## JUMA TRX2 LINE INPUT MODIFICATION

Drawn 2008-04 Review	2008-04-10		Serial no	Sheet	Cooperator's doc no	
Appr		JUMA	TRX2 SSB/CW TRANSCEI	VER	OH7SV	
Replaces OH7SV	-	MAIN	BOARD		Dwg no	Rev
Replaced by	1	LINE	INPUT MODIFICATION

## (2) JFET TR12 ADDED:

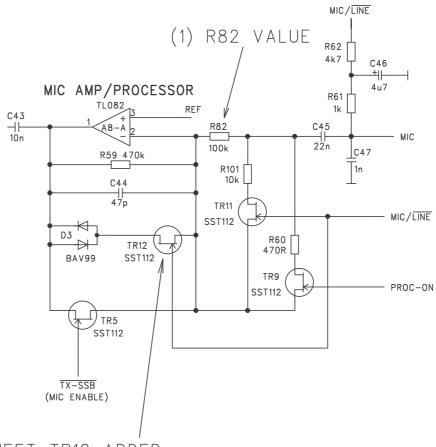
DISCONNECT DIODE D3 COMMON TERMINAL AND
RECONNECT IT WITH ADDITIONAL JFET TR12 BACK TO TR5.
CONNCET THE TR12 GATE TO THE MIC/LINE CONTROL SIGNAL.
REFER ALSO TO THE ORIGINAL SCHEMATICS
